Following are the Government's responses to questions received concerning Sources Sought Notice No. QPL—FPR-Kits:

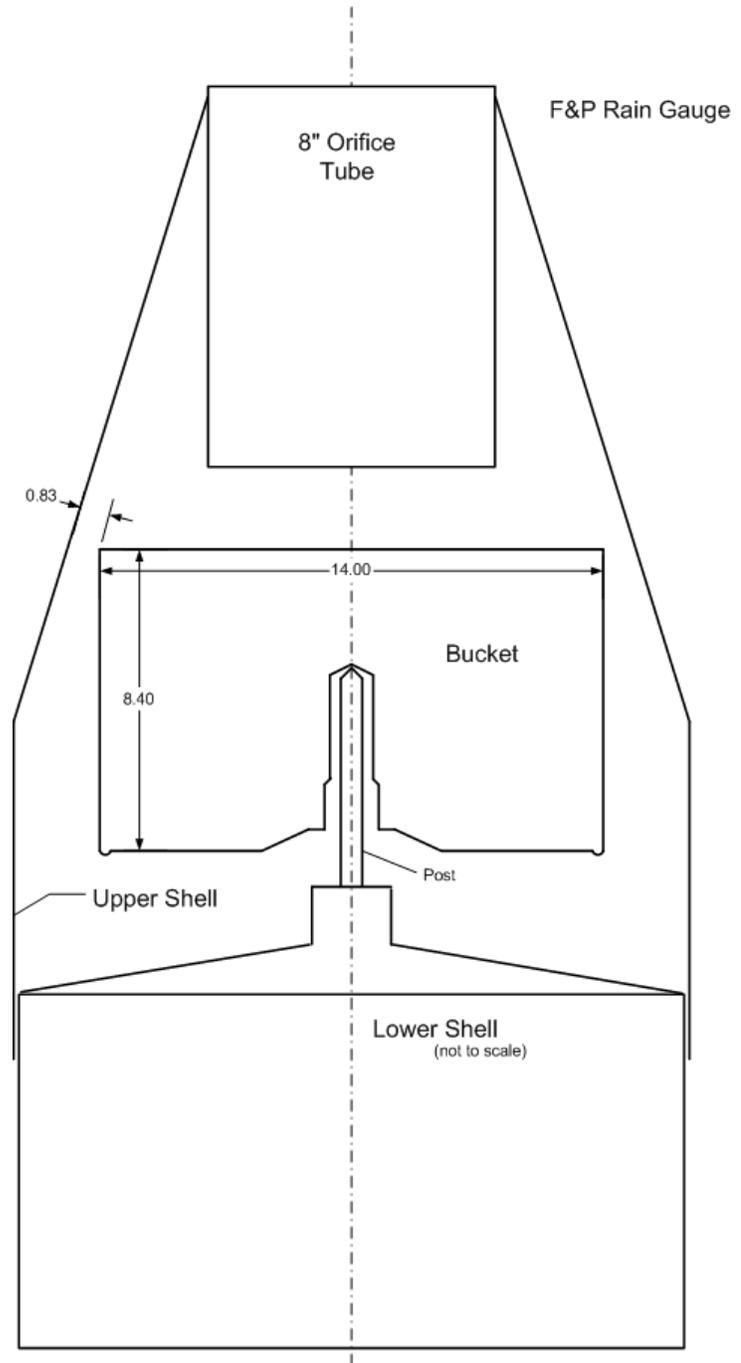
Question #7: Could you please send me the inside dimensions (diameter and height in inches or mm) of the collecting bucket, as well as the space between the bucket and the inside wall of the F&P shell (cover)?

Response: Please refer to this picture:
